HURON-CLINTON METROPOLITAN AUTHORITY
FLATROCK DAM 2008 REPAIRS

AS-BUILT ("A.B.") DRAWING NOTES	JRR	By	Appd.	01.10
Revision				MM.DD.YY
BID SET				05.08
OWNER REVIEW				03.08
QA/QC (95%)				02.08
ROAD COMMISSION SUBMITTAL (WCOPS)				01.08
REVISIONS PER MDO				12.13.07
PERMITS (90% SET)				10.31.07
60% REVIEW				07.07.10
Issued		By	Appd.	MM.DD.YY

SOIL EROSION CONTROL AND MISC. DETAILS

**RIGHT SIDE, LOCK
DEMOLITION PLAN**

K
C.102

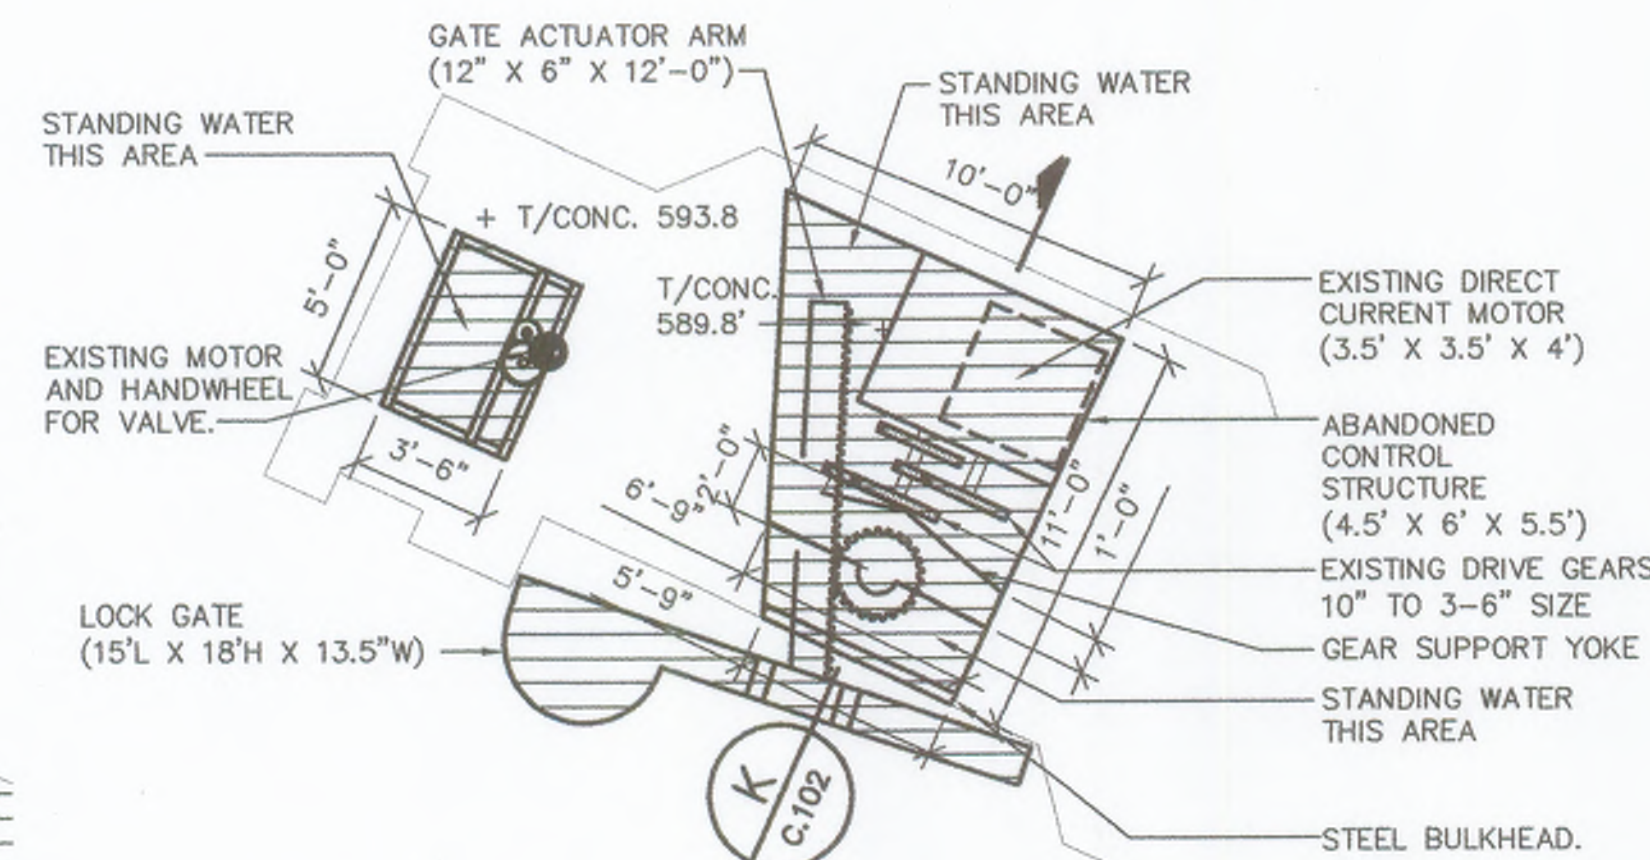
A.B. 1. DEMOLISH AND REMOVE ALL EQUIPMENT AND MISC. METALS IN THE AREAS SHOWN. THIS SHEET DEPICTS MOST OF THE SIGNIFICANT MECHANICAL EQUIPMENT THAT EXISTS AT THE LOCK CONTROL STRUCTURES. THE INTENT IS THAT ALL ABANDONED EQUIPMENT IN THE REMOVAL AREAS OF THE CONTROL STRUCTURES BE REMOVED AND DISPOSED OF BY THE CONTRACTOR. DIMENSIONS ARE SHOWN ONLY FOR THE PURPOSE OF CONVEYING THE APPROXIMATE SIZE OF THE REMOVALS.

2. IN BOTH STRUCTURES, REMOVALS SHALL INCLUDE ALL VISIBLE EQUIPMENT, GATE ACTUATOR ARMS, MOTORS, GEARS, DRIVE SHAFTS, LADDER RUNGS, SUPPORT STEEL, STEEL STRUCTURES AND APPURTENANCES FROM THE DEWATERING ELEVATION AND UP. A.B. THE LOCK GATES ON BOTH THE LEFT AND RIGHT SIDES SHALL BE REMOVED IN THEIR ENTIRETY (TO FULL DEPTH). A.B.

3. SUPPORT POINTS AND ANCHORAGES INCLUDING GATE PIVOTS AND OTHER METAL APPURTENANCES (INCLUDING THOSE BELOW WATER) REMAINING IN THE EXISTING CONCRETE SHALL BE CUT FLUSH SO AS TO AVOID SHARP OR JAGGED EDGES, SNARE POINTS OR OTHER HAZARDS. A.B. (LADDERS IN WELLS COULDN'T BE CUT FLUSH - WARNING) A.B.

GENERAL CONTRACTOR DEMO'D EQUIPMENT PRIOR TO ASBESTOS ABATEMENT WHILE JOB'S WORK WASN'T PRESENT, (AS SPEC'D.). B.C. BLAUGHT IN ABATEMENT CONTRACTOR AFTER BEING CHARGED FOR CLEAN-UP. - NEVER RECEIVED ABATEMENT RESULTS FROM B.C. DEBATE MANY ATTEMPTS. A.B.

LEFT SIDE PLAN
SCALE: 1"=20'-0"

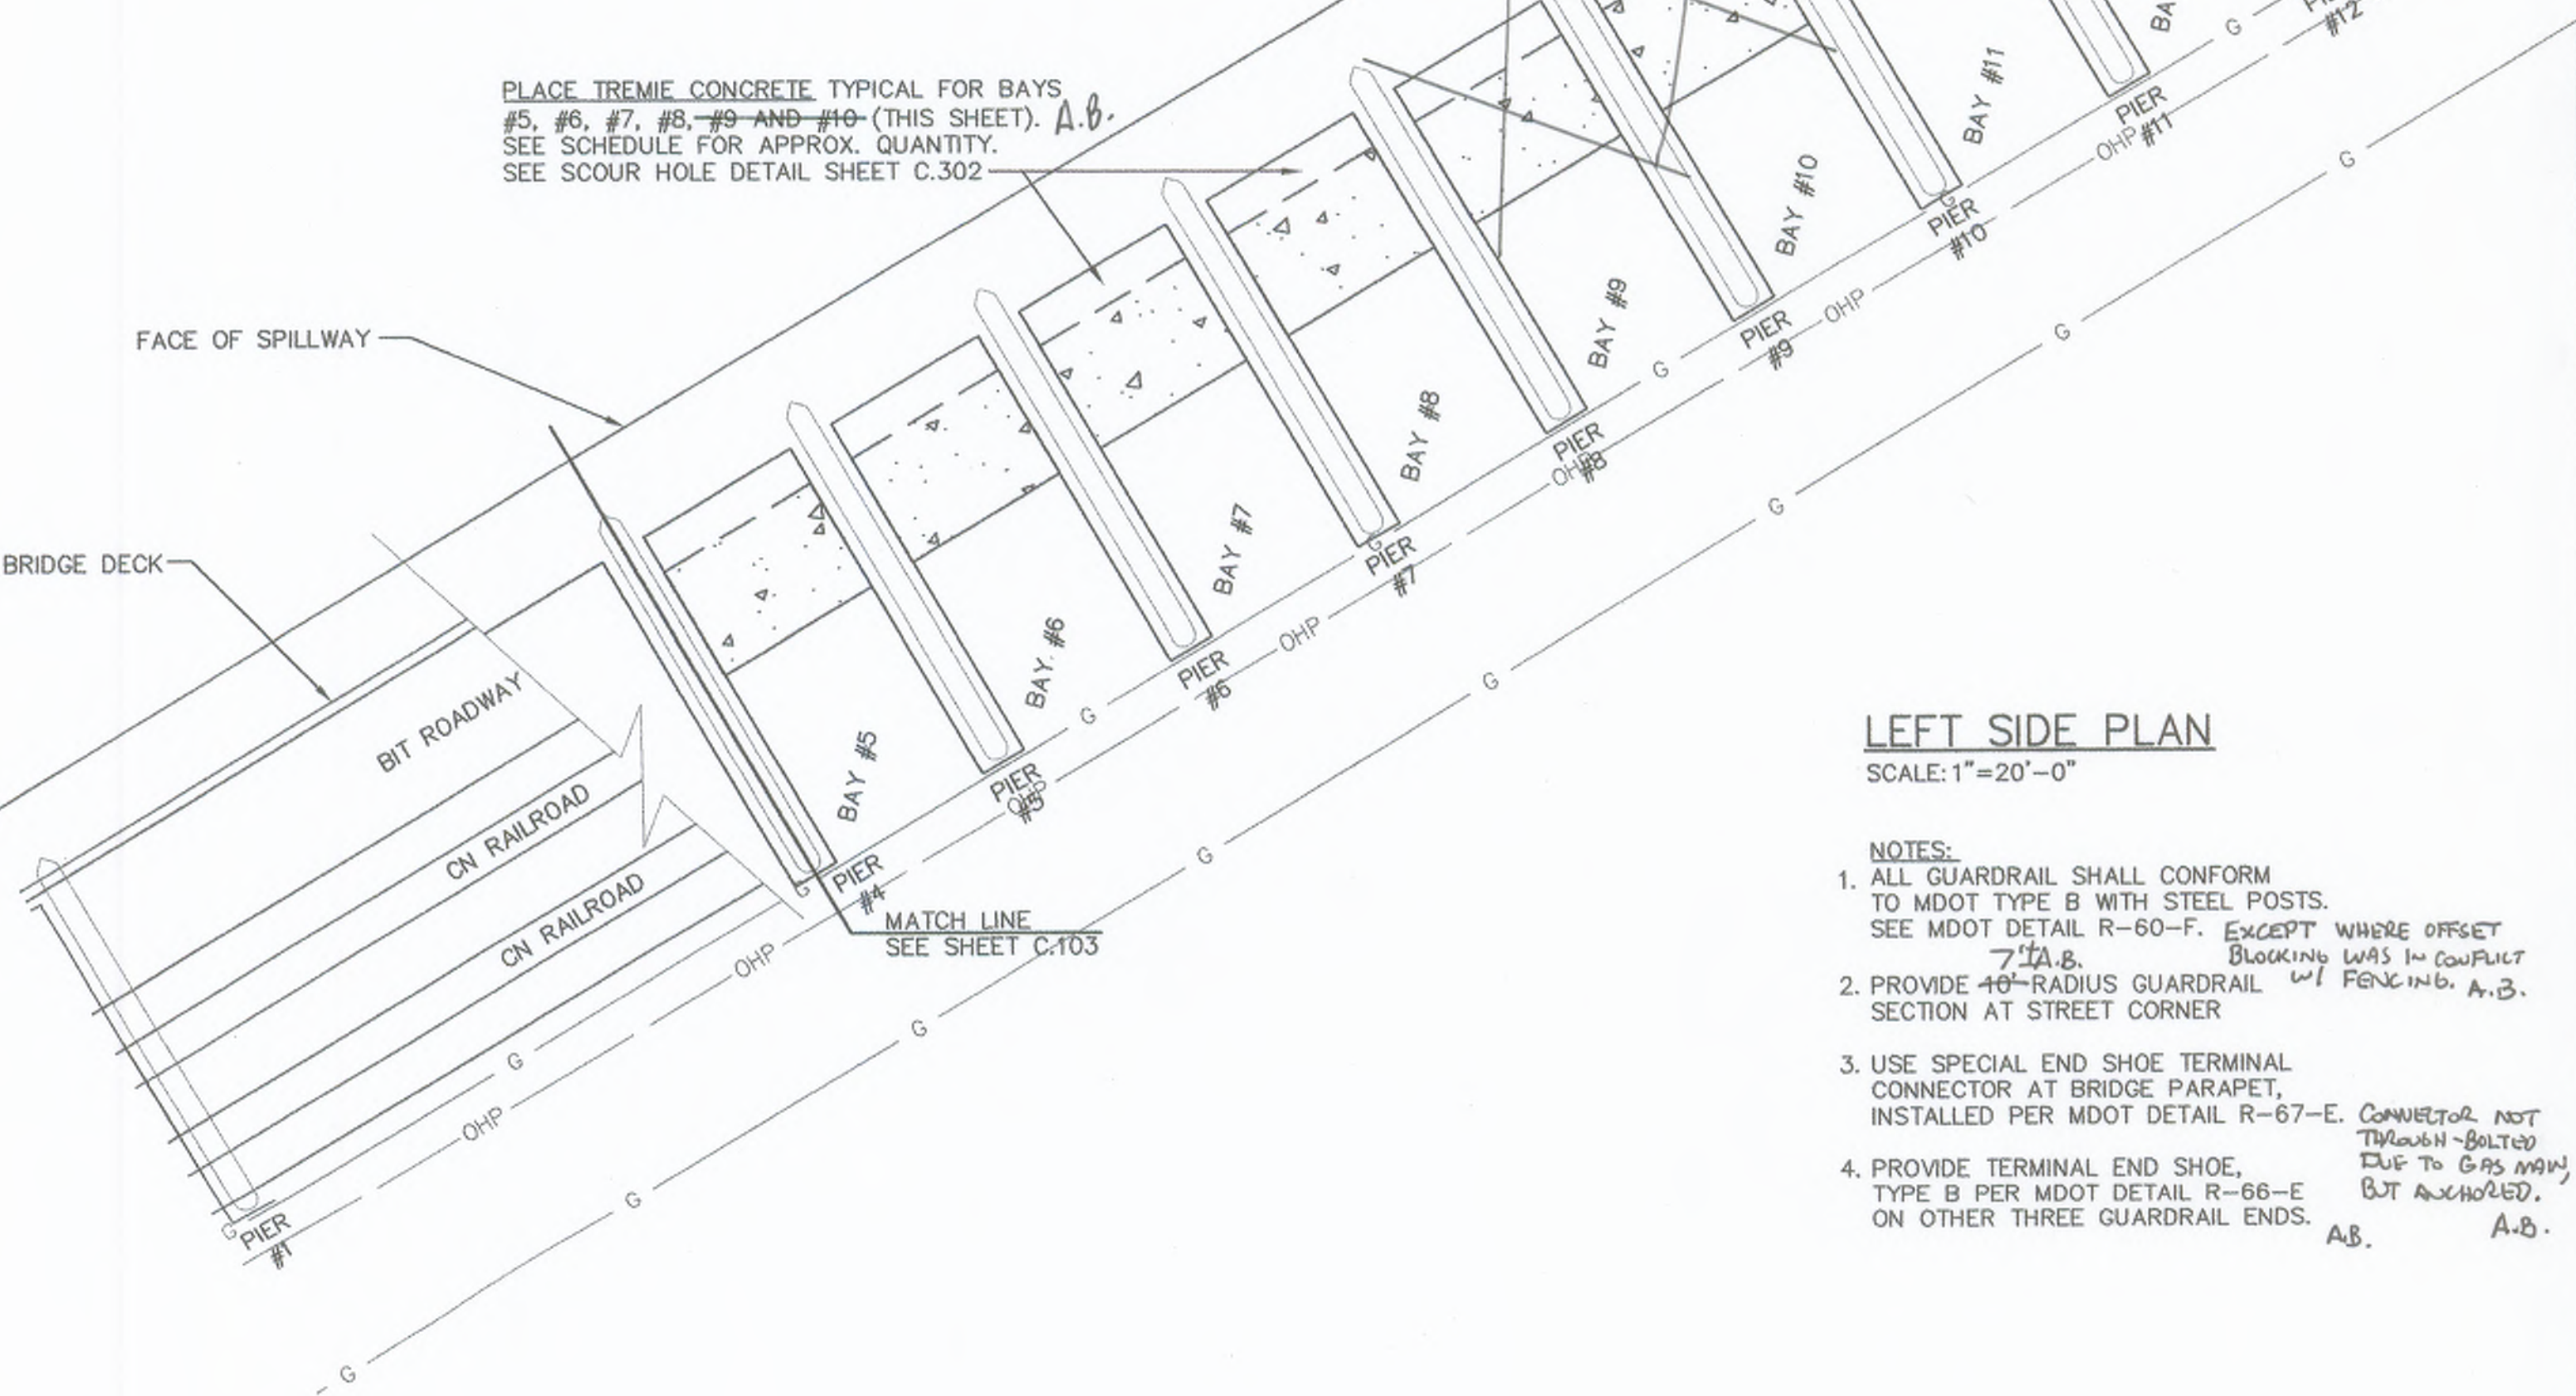
BAY	APPROX. QTY. (CY)
#5	47 ± 25 ± A.B.
#6	48 ± 15 ± A.B.
#7	56 ± 20 ± A.B.
#8	50 ± 24 ± A.B.
#9	45 ± 0 A.B.
#10	45 ± 0 A.B.

DETAIL
SCALE: 1/4"=1'-0"

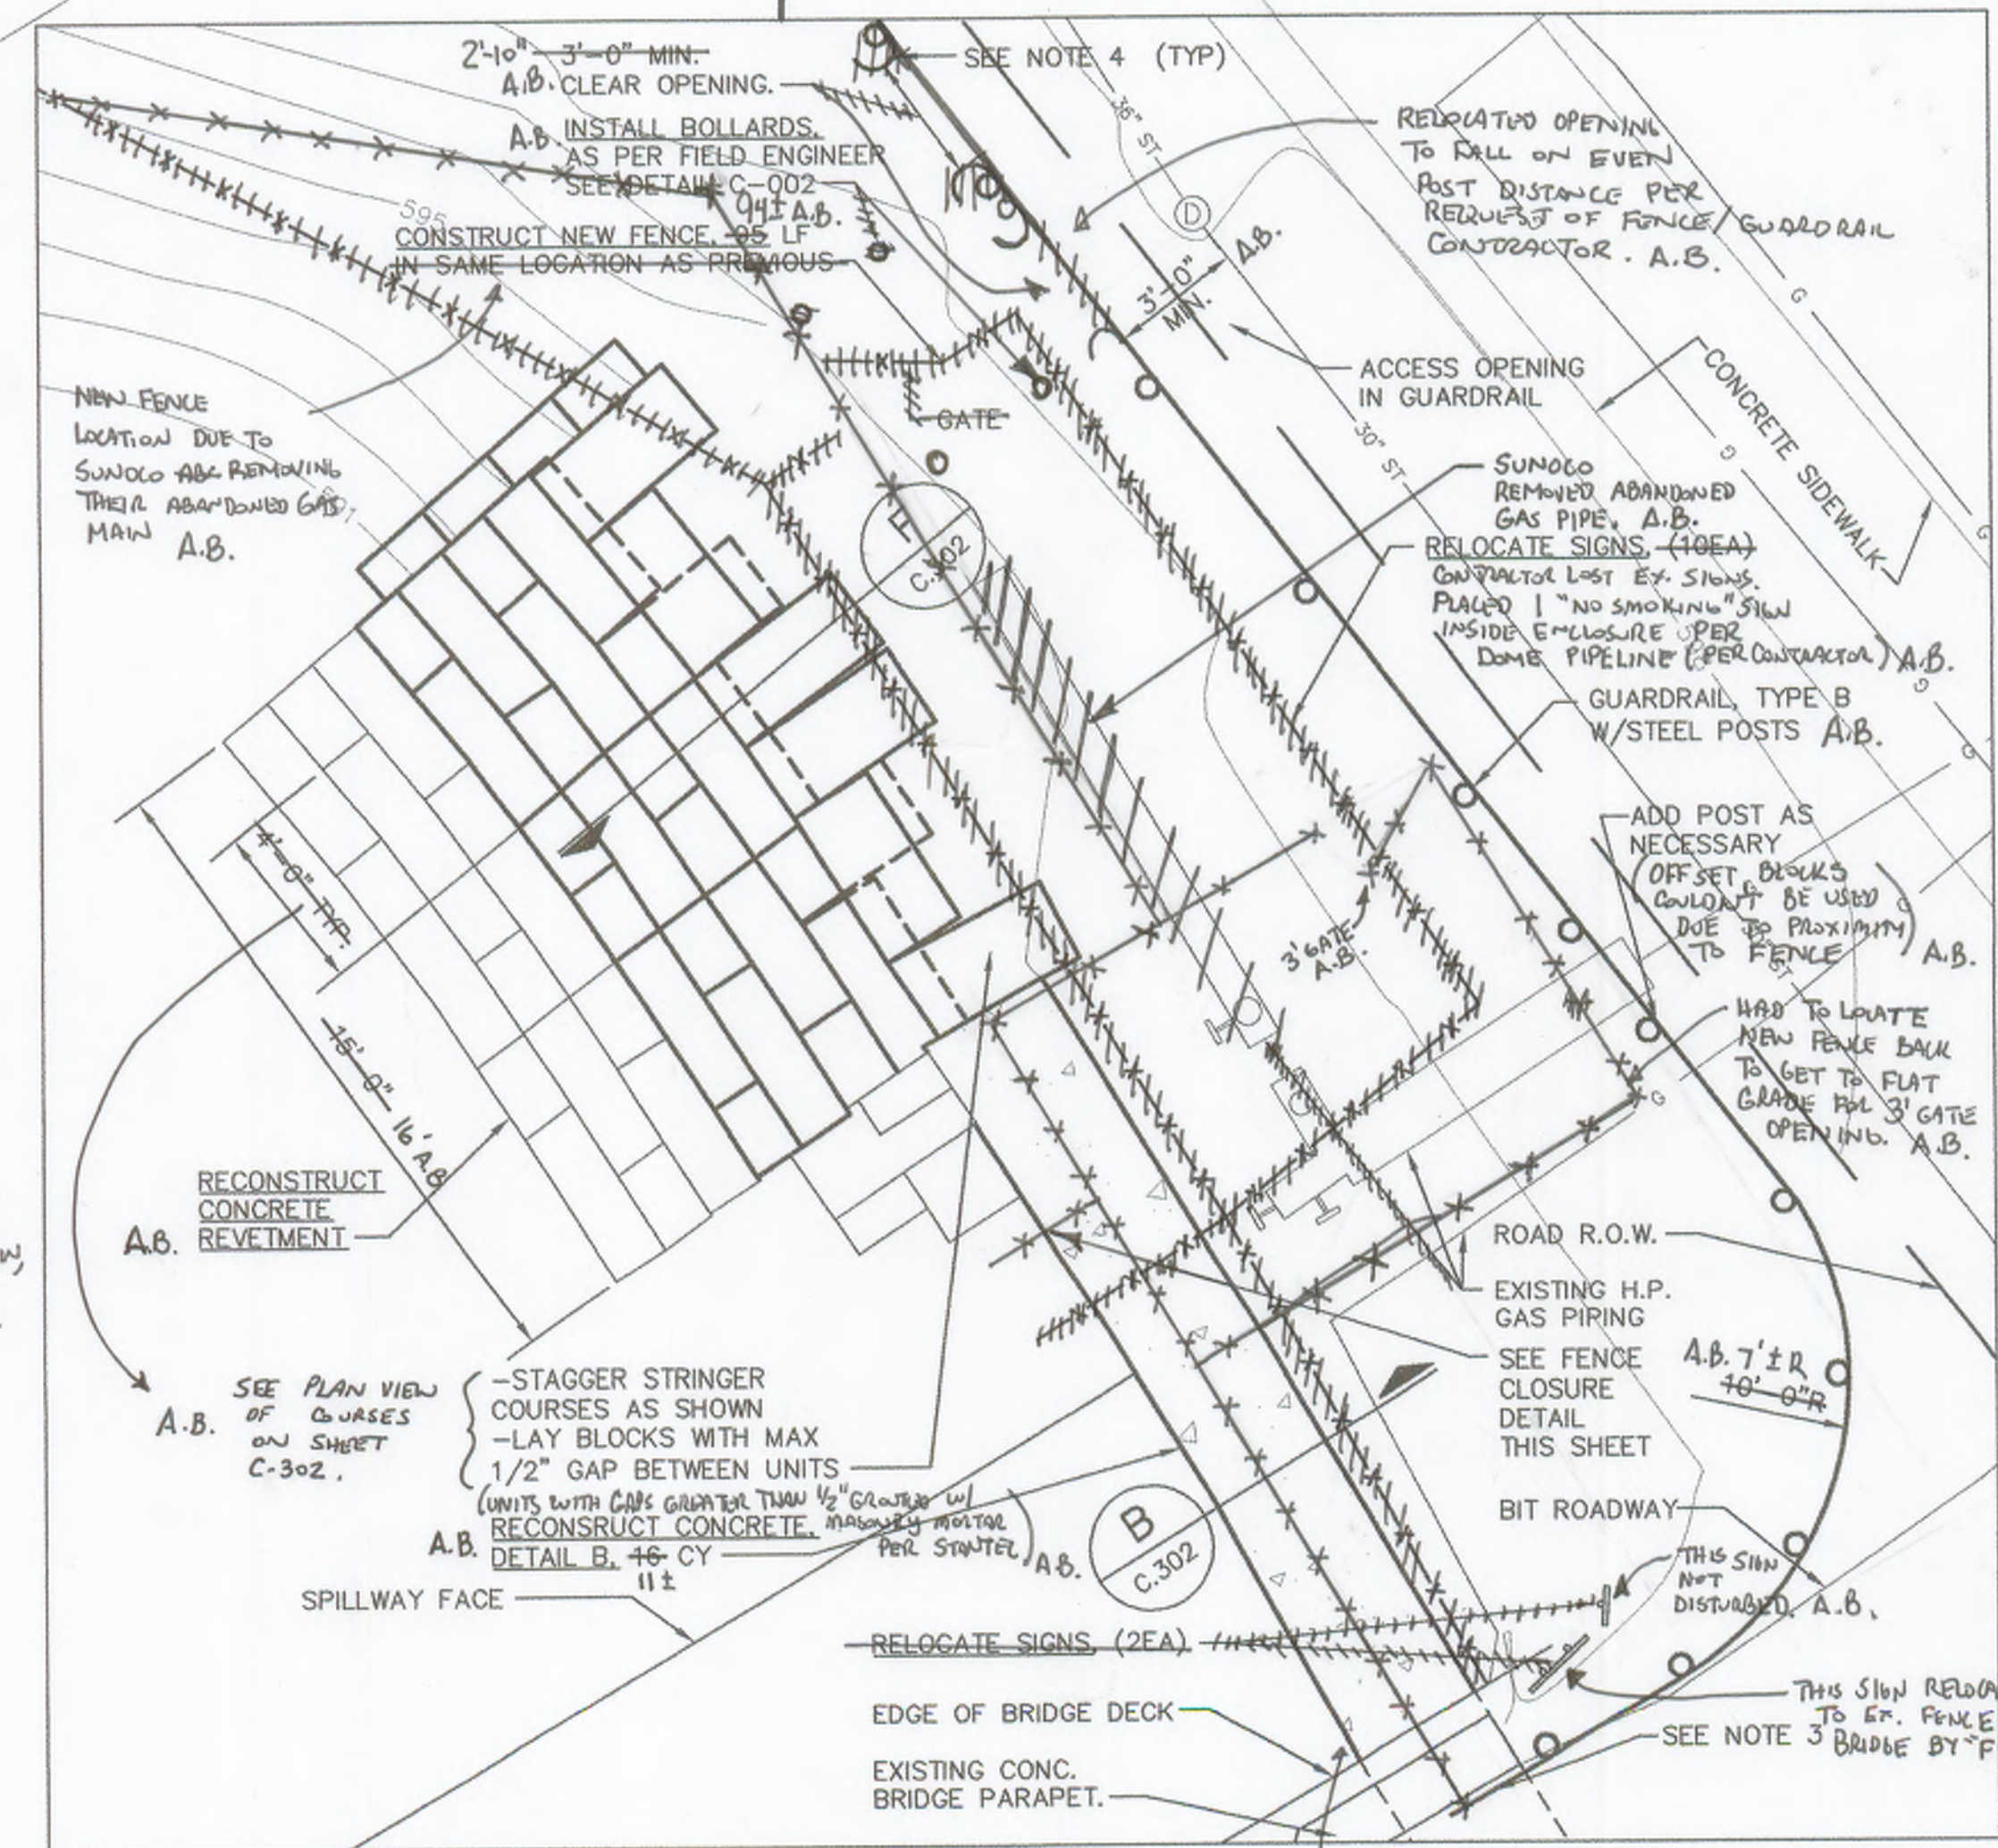
- NOTES:
- ALL GUARDRAIL SHALL CONFORM TO MDOT TYPE B WITH STEEL POSTS. SEE MDOT DETAIL R-60-F. EXCEPT WHERE OFFSET BLOCKING WAS IN CONFLICT WITH FENCING, A.B.
 - PROVIDE 10'-RADIUS GUARDRAIL SECTION AT STREET CORNER.
 - USE SPECIAL END SHOE TERMINAL CONNECTOR AT BRIDGE PARAPET, INSTALLED PER MDOT DETAIL R-67-E. CONNECTOR NOT THROUGH-BOLTED DUE TO GAS MAIN, BUT ANCHORED. A.B.
 - PROVIDE TERMINAL END SHOE, TYPE B PER MDOT DETAIL R-66-E ON OTHER THREE GUARDRAIL ENDS. A.B.
